**Addendum No. 1**

RE: Contract ID: C201840  
WBS# 34440.3.8  
F.A# NHF-0017 (70)  
Beaufort County (R-2510D)  
Bridge Over Tar River on US-17

**September 18, 2007 Letting**

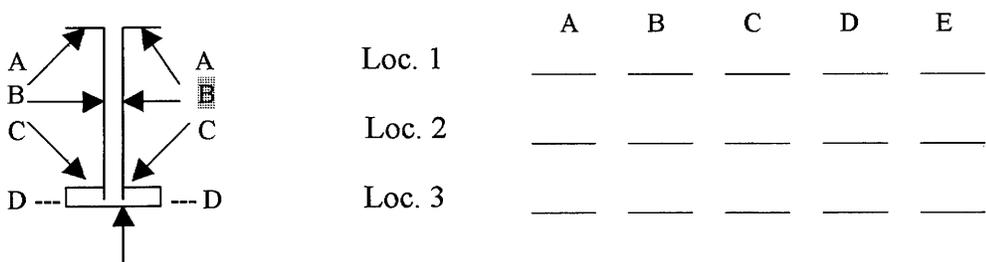
On Page No. 26, a revision was made to the third full paragraph (including diagram) under the section entitled "Inspection". Please void Page No. 26 in your proposal and staple the revised Page No. 26 thereto.

The dry film thickness is measured at each spot as indicated on the attached diagram at no less than three random locations along each girder in each span. Also dry film thickness is measured at no less than **five** random spots per span on diaphragms/“K” frames. Each spot is an average of three to five readings in accordance with SSPC PA-2.

E Randomly select one A, one C and one D spot along with B and E.
